DATE: February 16, 2022  
TO: Town of Garden City Planning Commission  
CC: Riley Argyle  
FROM: Quinn Dance, P.E.  
SUBJECT: Sun Communities – Bear Lake RV Resort Preliminary Plat Review

**RE:** Response to Bear Lake RV Resort Preliminary Plat Review by JUB (2/16/22)

DATE: February 16, 2022  
TO: Town of Garden City Planning Commission  
CC: Riley Argyle  
FROM: Quinn Dance, P.E.  
SUBJECT: Buttercup Acres (7 lots) Final Plat Review

| C002      |                   |

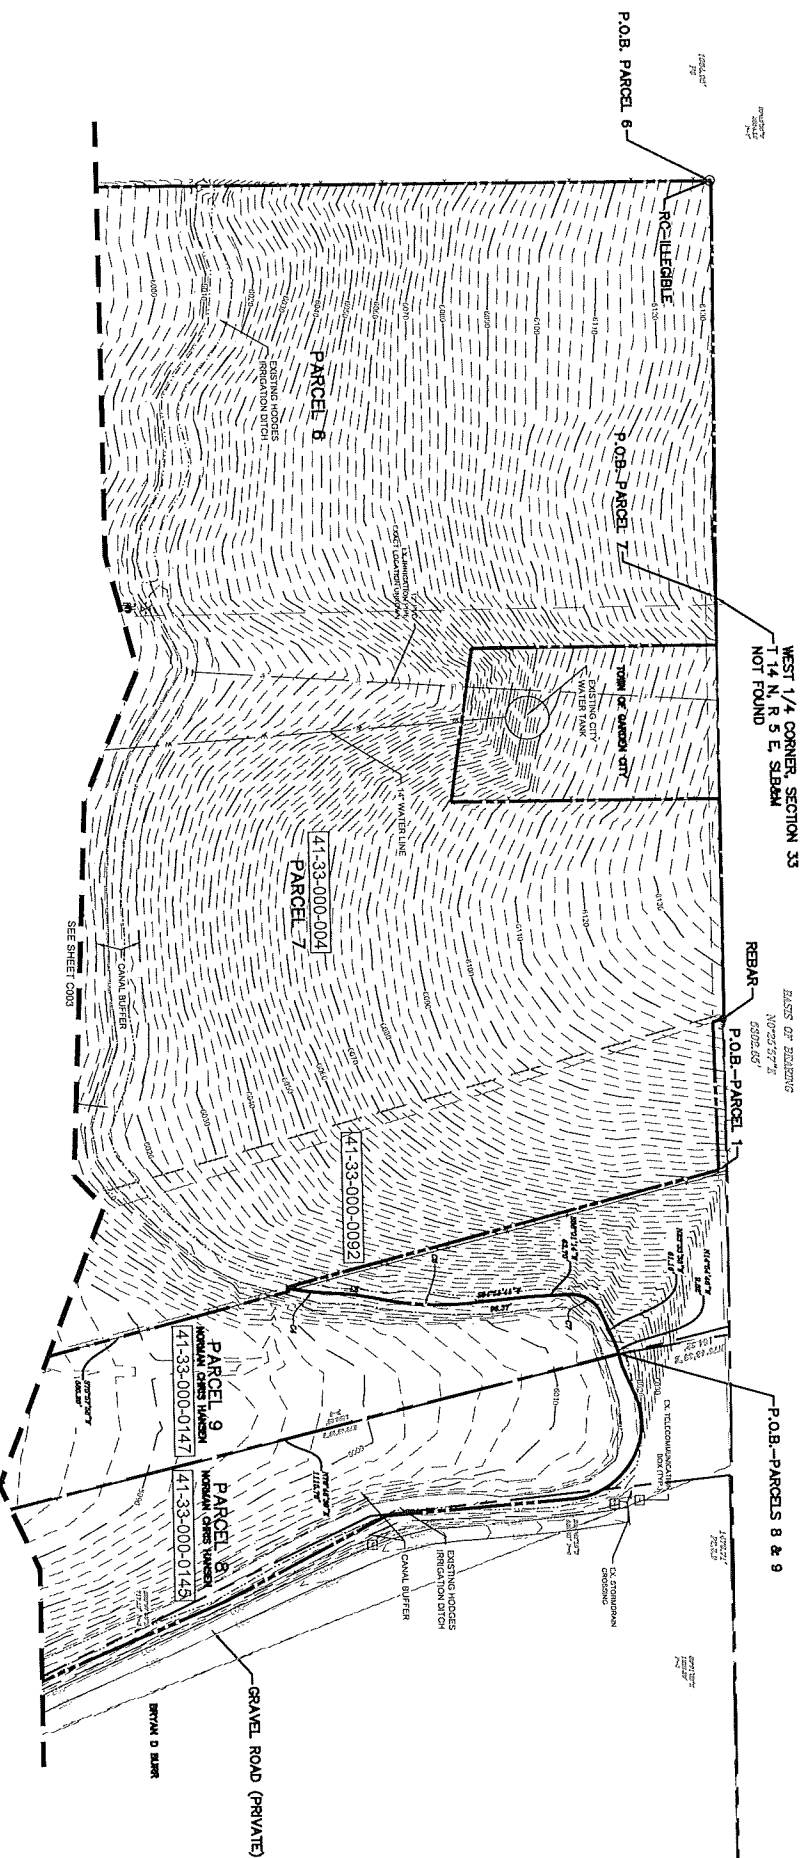
3. Include the existing wells within 100' of the development. Visit Map (utah.gov) as a potential resource for existing wells.  
**Response:** Research indicates two wells within 100' of the property they are shown on the existing conditions plans. (Additional research ongoing)

1. REMAIN WAS NOT CONSIDERED A STUDY TO DETERMINE FLOOD HAZARD FOR THIS LOCATION
2. THERE ARE NO EASEMENTS FOR OVERHEAD POWER LINES OR FOR WATER LINES
3. ADD
4. TWO WELLS LOCATED WITHIN 100' OF THE PROJECT SITE:  
N 1570 FT W 88S FT FROM SW CORNER, SEC 23 T 14N R 3E  
N 1570 FT W 88S FT FROM SW CORNER, SEC 23 T 14N R 3E

**COMPOSITE UTILITY PLAN**  
 LAND USE SUBMITTAL  
**BEAR LAKE RV RESORT**  
 GARDEN CITY, RICH COUNTY, UTAH

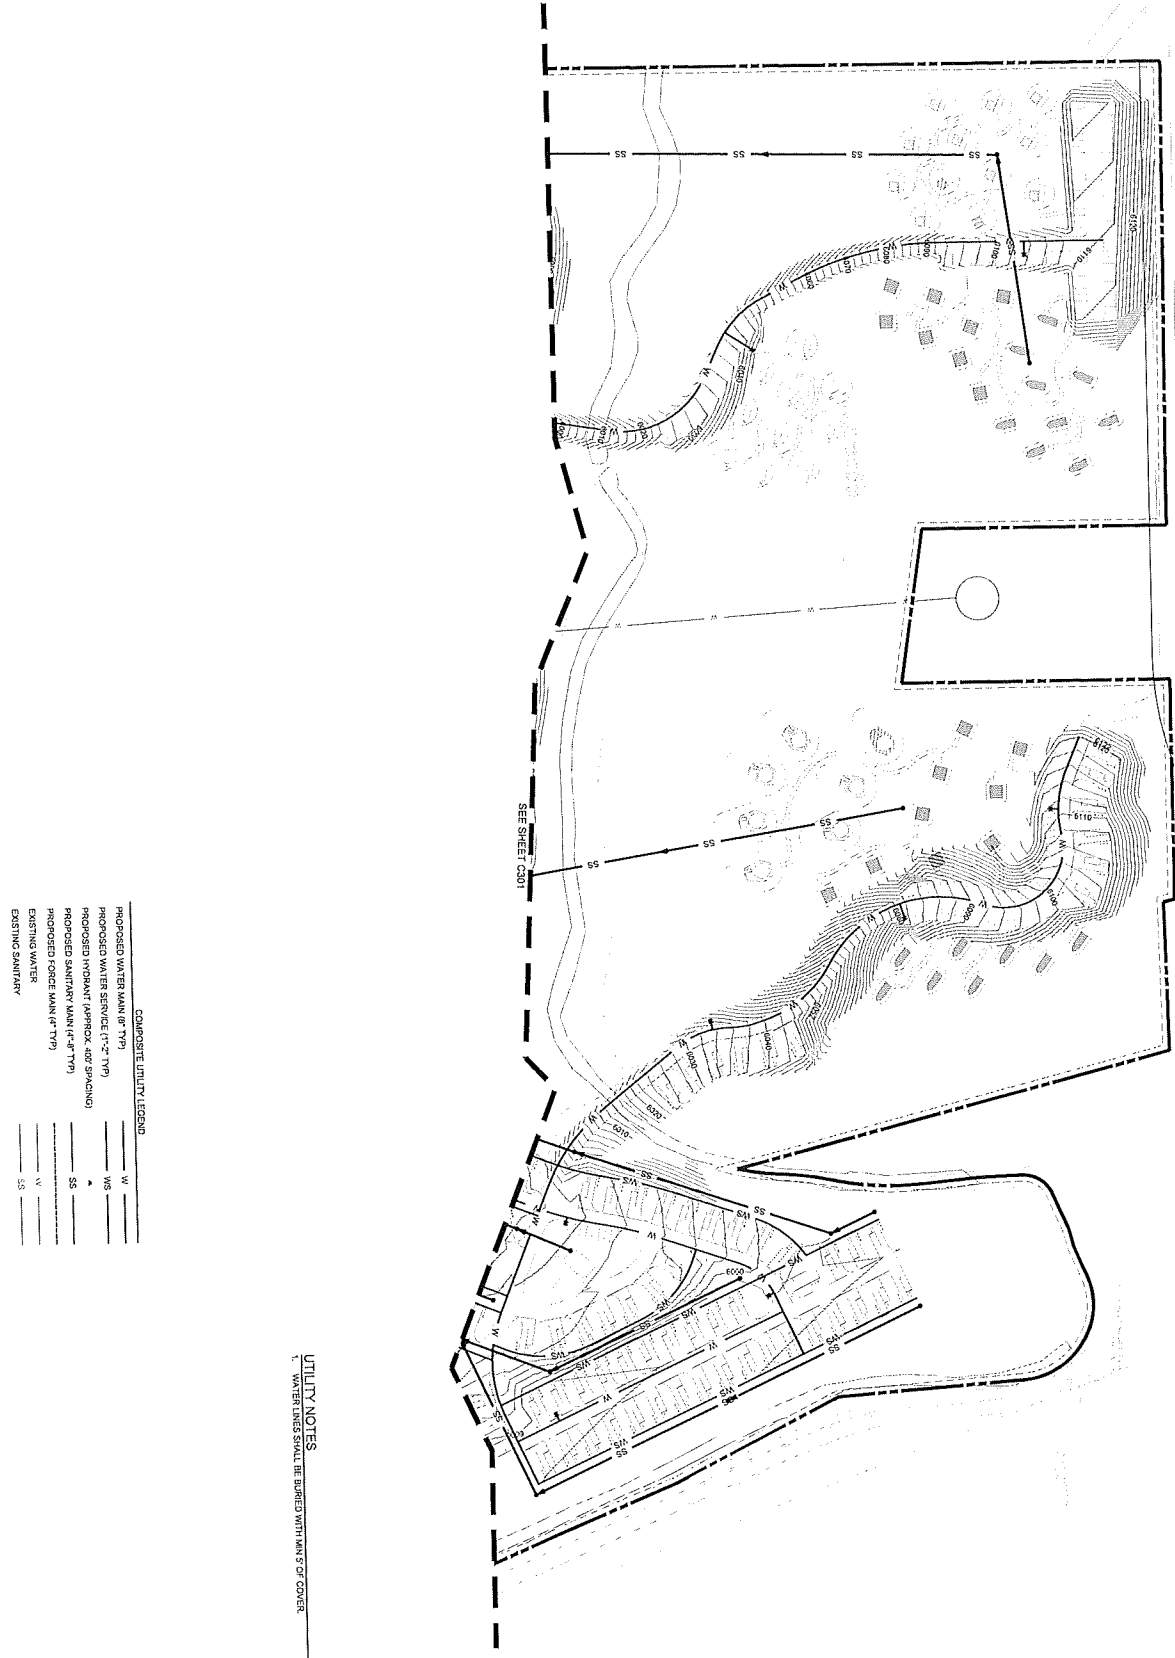
3. Verify that underground water is at the required 5' bury depth.  
[Response: Acknowledged, general note 1 added to C301 \(sheet 9 of 10\) to indicate this standard.](#)

5. Provide a location for the bulk meter for the development. We will only allow one connection/bulk meter to the existing culinary system.  
[Response: See sheet C301 \(9 of 10\) for proposed location of master meter for the property.](#)

**UTILITY NOTES**  
 1. WATER LINES SHALL BE BURIED WITH MIN 5' OF COVER.

| C301      |                  |

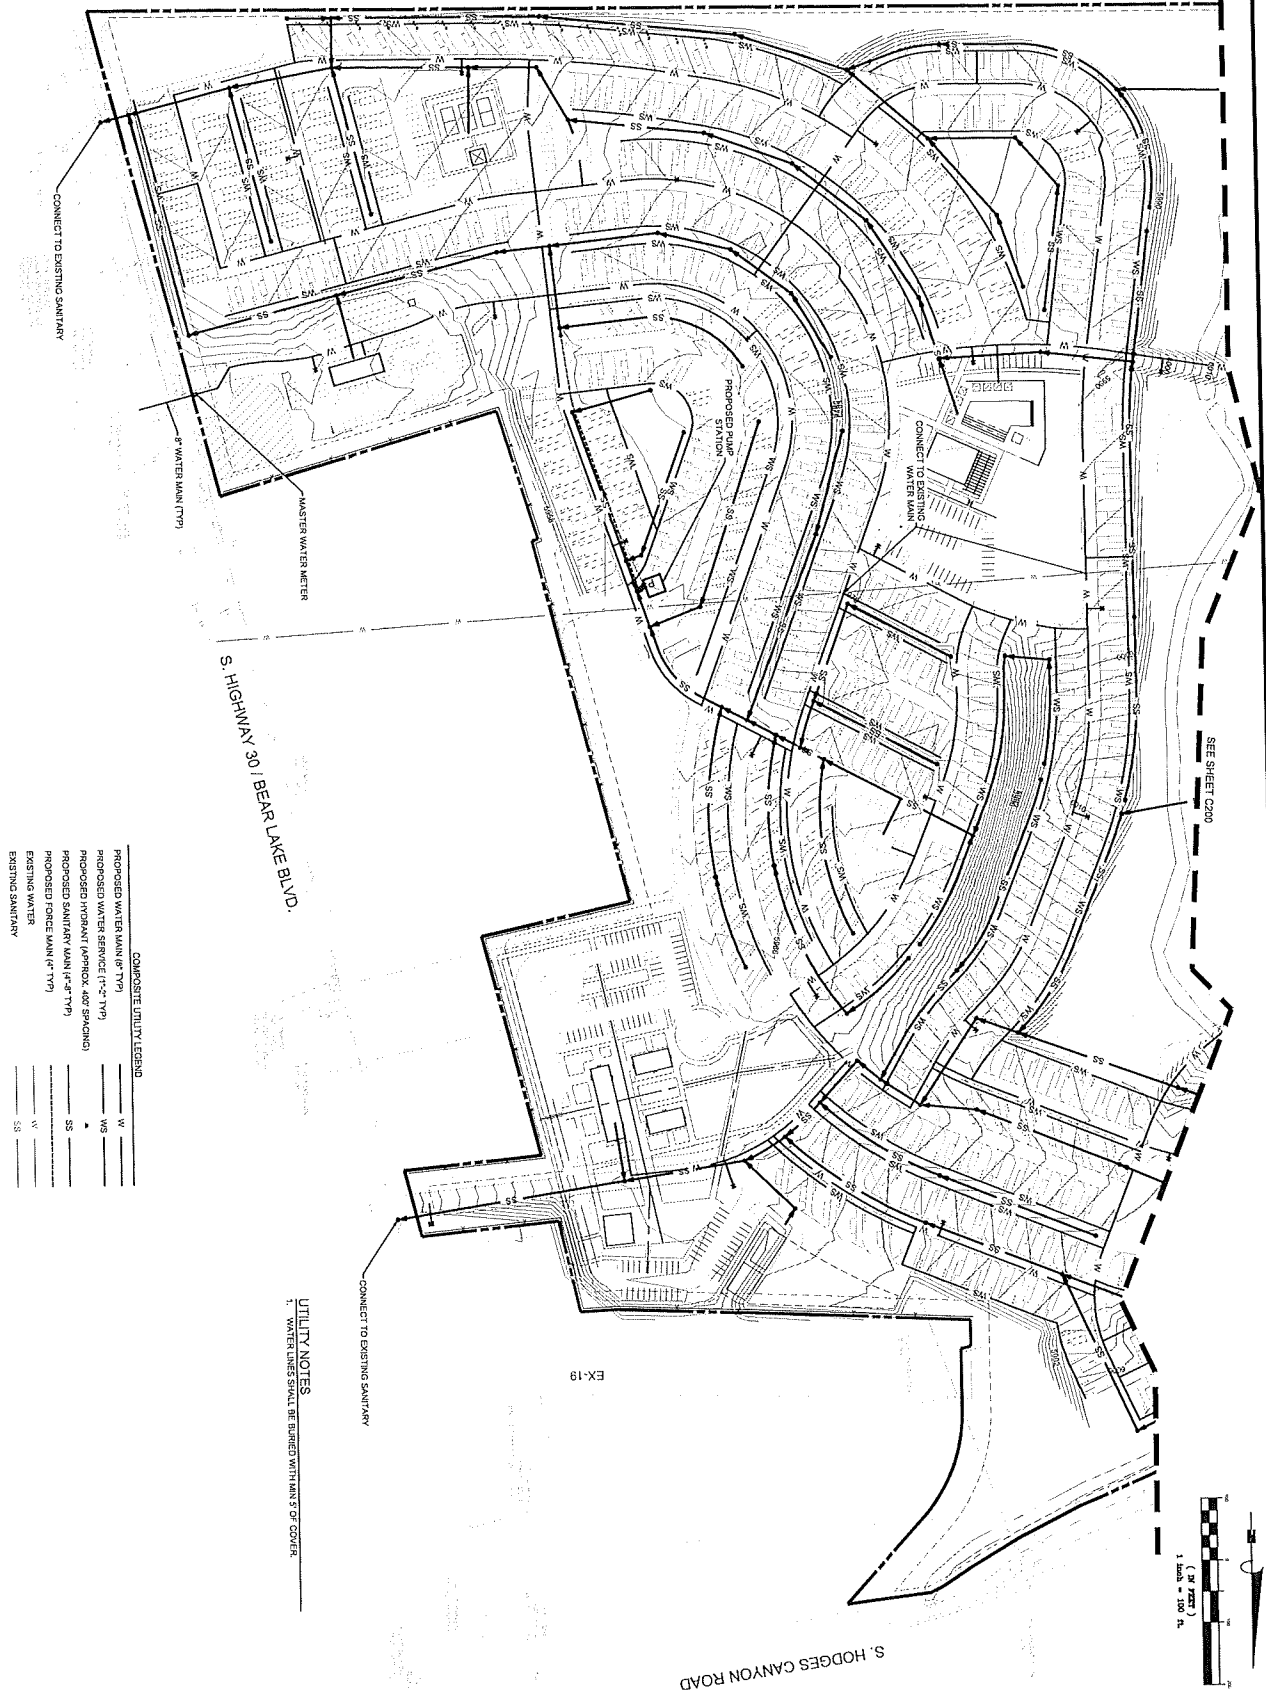
6. Provide water main sizes.  
[Response: See Sheet C301 \(9 of 10\) for general utility sizing. Will be refined on final plan.](#)
7. Proposed roads into Phase 2 will exceed 8% grade. Additional design should be considered which could include additional curves to lengthen out the run of roadway to limit the steep grades.  
[Response: Acknowledged. Operations of the glamping models will be seasonal and final design will provide for minimum grade requirements or restrict access accordingly during winter months.](#)

1. WATER LINES SHALL BE BURIED WITH MIN 5' OF COVER.

FINAL PLAT

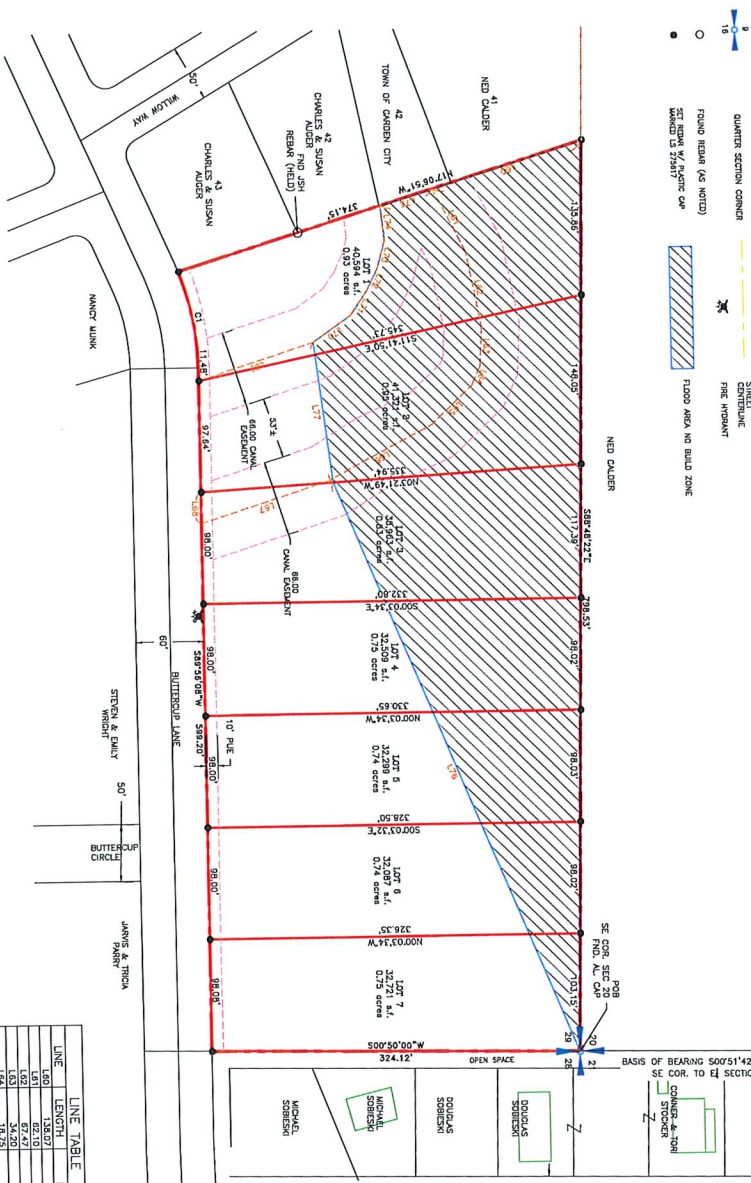
1. Provide the setback information on the plat.
2. Provide addresses per Rich County addressing system.
3. Verify that taxes are current.

1. Verify buildable envelope within Lot 1-3 and notate buildable area square footage on plat. With added setbacks the area may be too restrictive to a future property owner.

1. Provide agreement or information related to piping the canal and provide a signature block on the final plat for certification/approval by the canal companies.

1. Drainage will need to be handled along the frontage of Buttercup Lane. Garden City standards require an 18" culvert for a min. of 40' in length. Provide additional details about the construction and grading along Buttercup Lane.
